COMMUNITY DEVELOPMENT DEPARTMENT REPORT

SUBJECT: Regency at River Valley Phase 3 –
CUP, MDA
H-2026-0010

LOCATION: 3270 E. River Valley St., in the NW 1/4
of Section 4, T.3N., R.1E. (Parcels:
S1104233975, S1104234010 &
R7476320020)

West Façade With Year 1 Trees and Fence

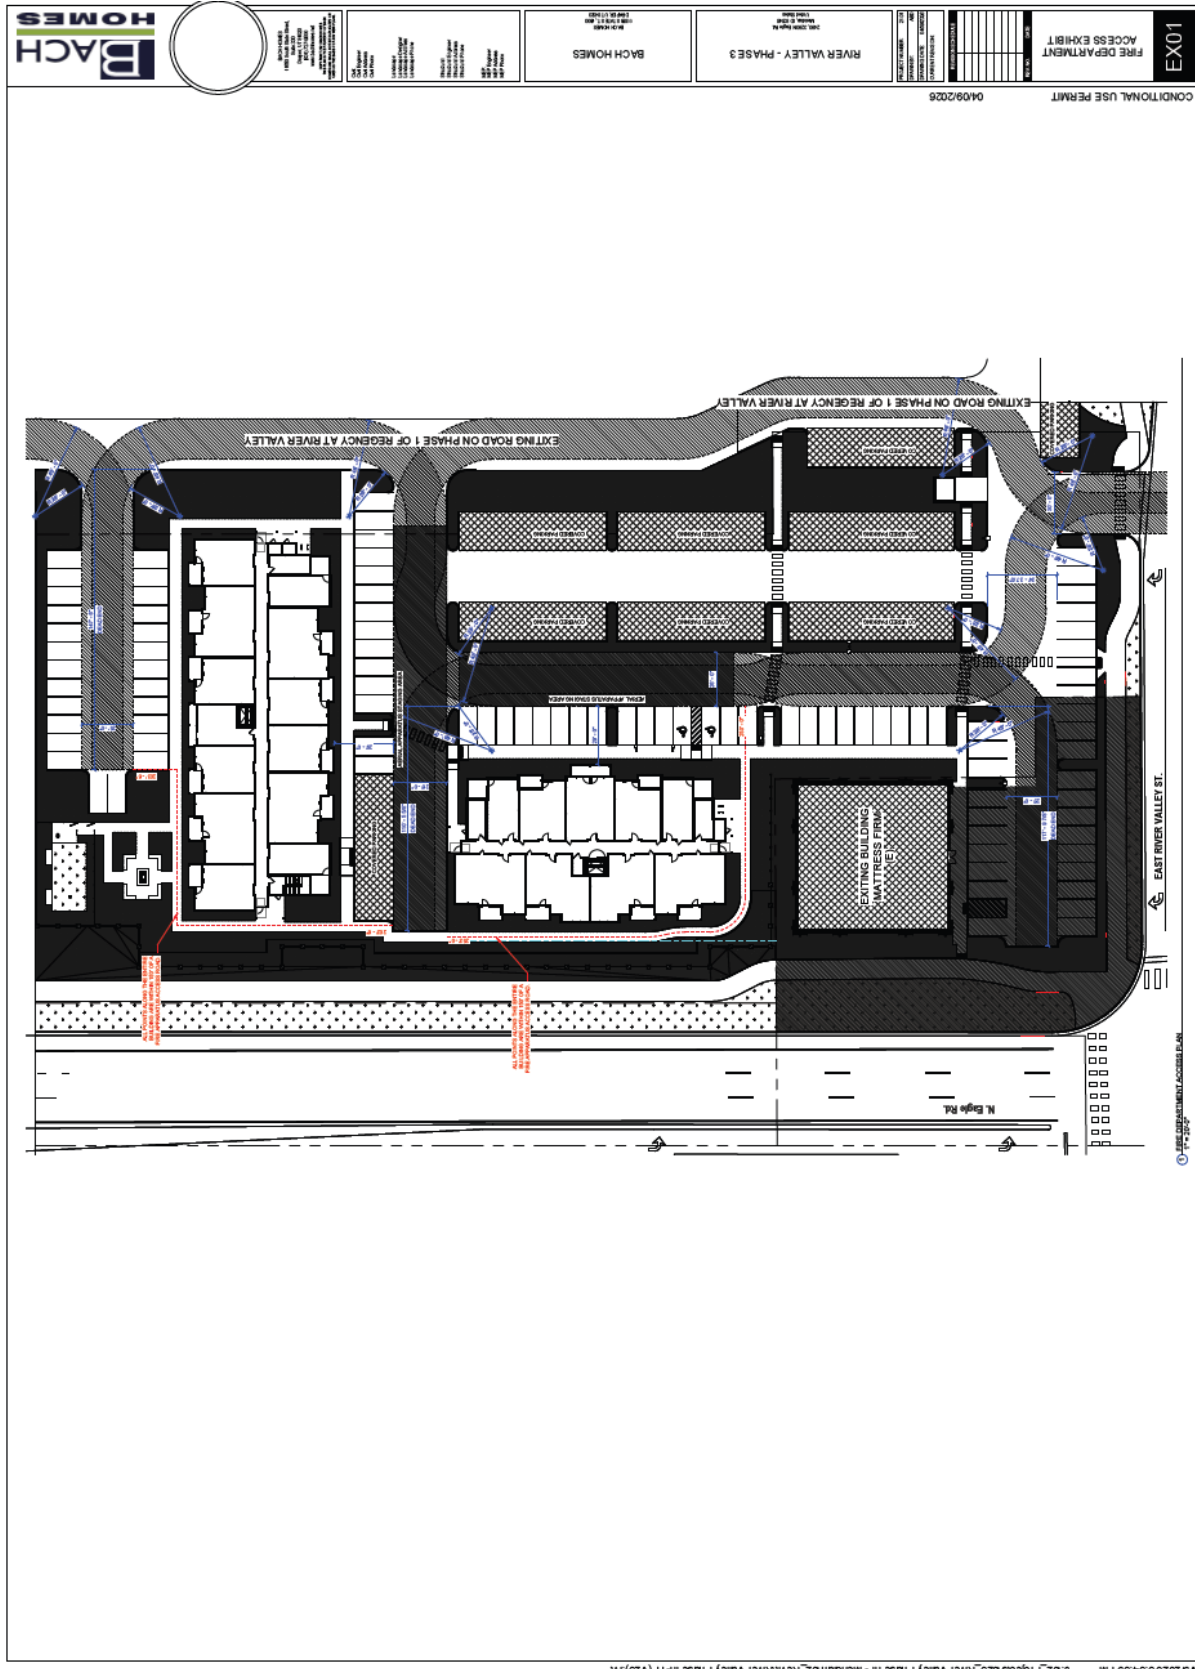
The form of the proposed structures at 4-stories in height doesn't provide an adequate transition to existing single-story (with higher parapet) commercial structures to the north and south along Eagle Rd. A transition in building height should be provided from the commercial structures and the Eagle Road corridor to the 4-story buildings directly to the east.

The proposed 4-story structures do not integrate well with existing single-story commercial structures to the north and south along Eagle Rd., creating a height disparity between structures along the entryway corridor. Landscaping and a 10' tall berm and wall is proposed within the street buffer; however, with the building height proposed, it provides for little screening.

J. Cross-Section of Street Buffer along Eagle Rd. with Noise Abatement Berm & Wall

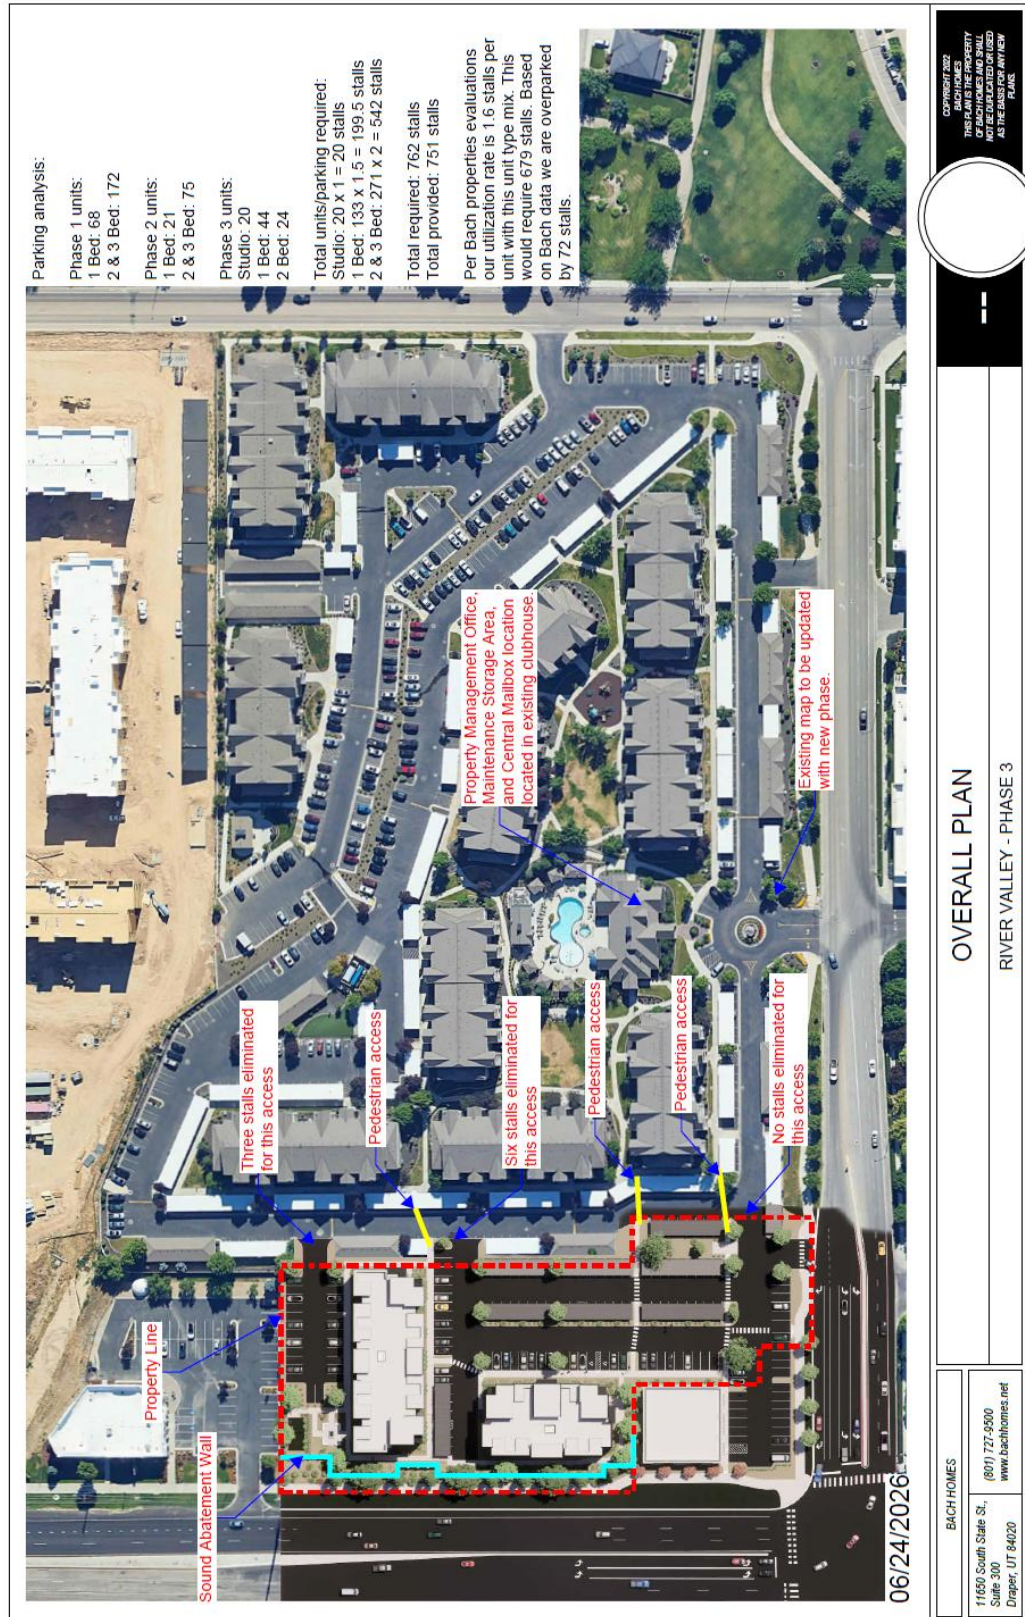
Noise abatement is required for residential uses along state highways per the standards in UDC 11-3H-4D. An 8’ tall pre-cast sound wall is proposed within the street buffer along N. Eagle Rd./SH-55 on top of a 2’ tall berm. A cross-section of the street buffer depicting the location of the wall is included below in Section VII.G and VII.J that depicts the top of the berm/wall to be 10’ higher than the elevation at the centerline of the state highway as required. **An exhibit should be submitted that demonstrates compliance with all of the required standards along with a detail of the wall that demonstrates it’s a sound attenuating material.**

K. Overall Site Plan

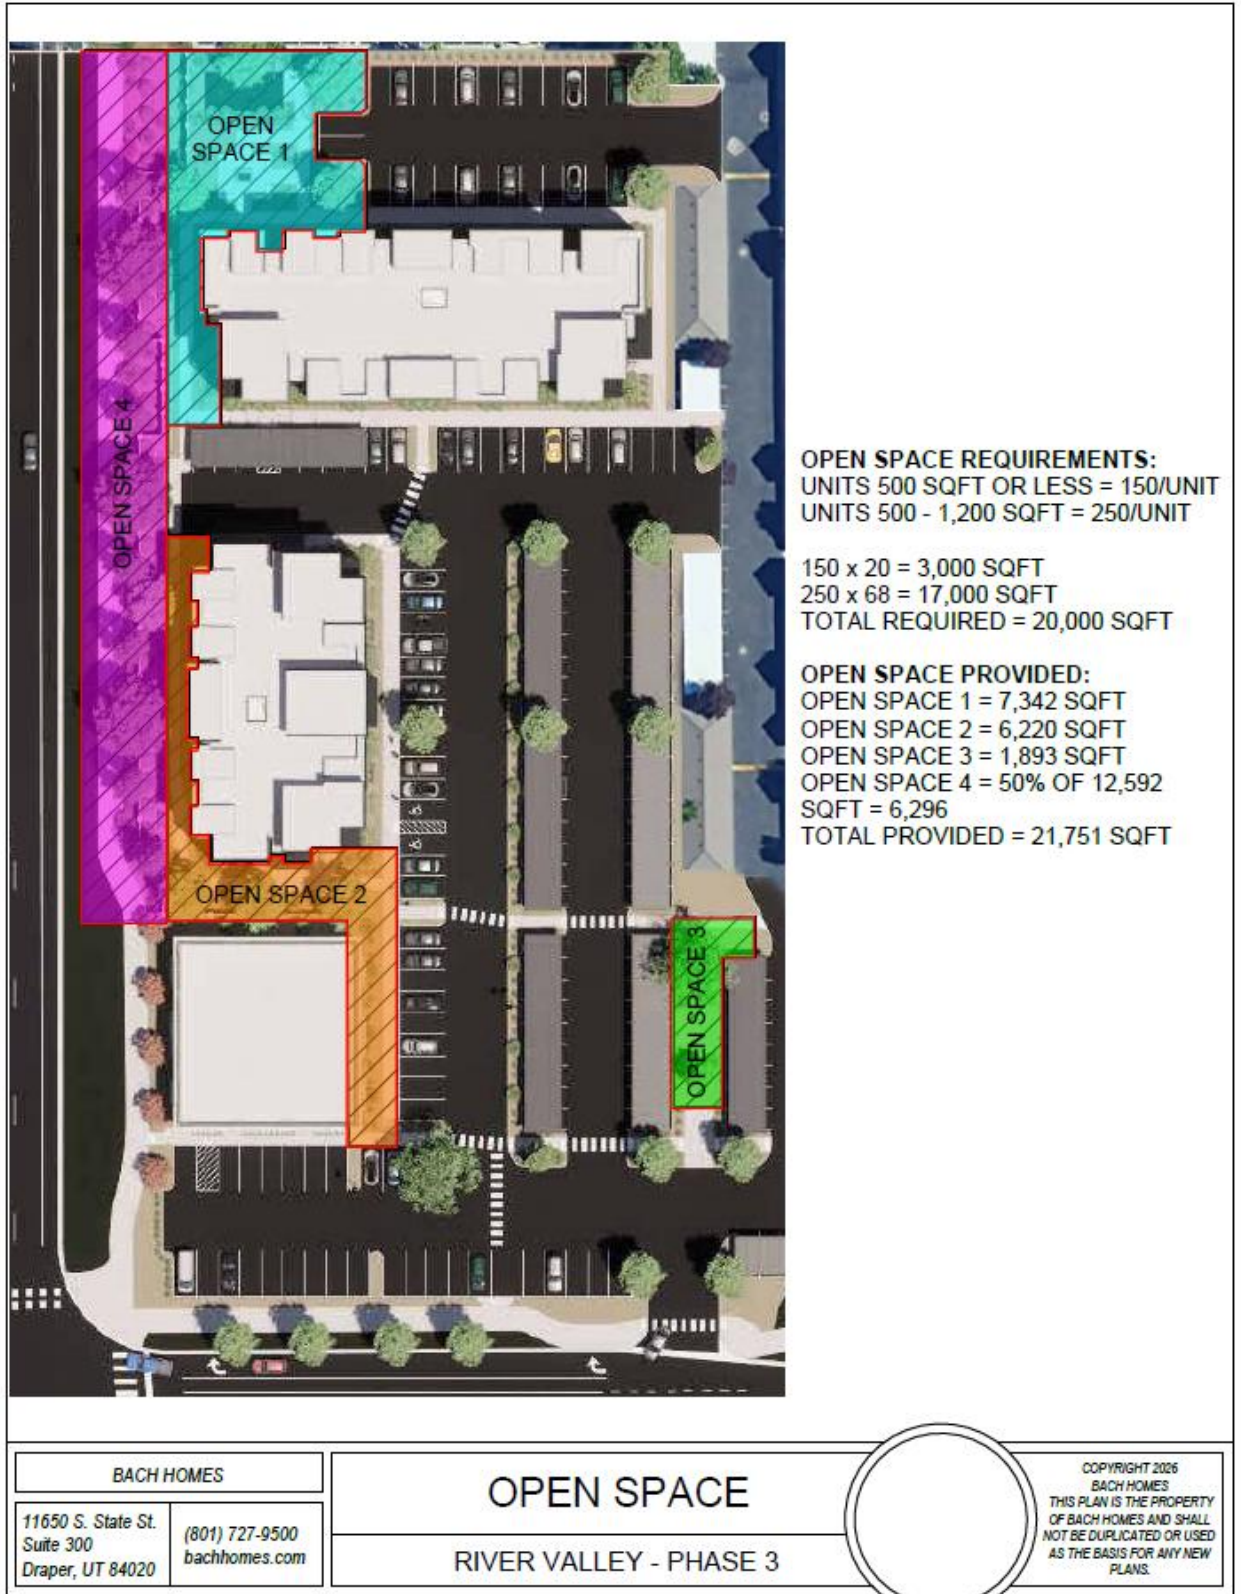
The overall site plan notes a total of nine (9) parking spaces were eliminated along the west boundary of Phase 1 that abuts this phase to accommodate cross-access drives. A parking analysis for the overall development is included – a total of 762 spaces are required, a total of 751 are provided, which is 11 fewer than the minimum required number. If Commission/Council decides to approve this application, revisions are needed to the site plan to accommodate the additional spaces on this site in order to comply with the minimum parking required for the overall development.

The property to the north was required to grant emergency vehicle access to this property if developed with a residential use (H-2022-0009 Copper Canary – DA Inst. #2022-048293). **The site plan does not depict an access drive from the north; the Fire Dept. will determine if this access is still necessary with access available through the adjacent development to the east via Records Ave.**
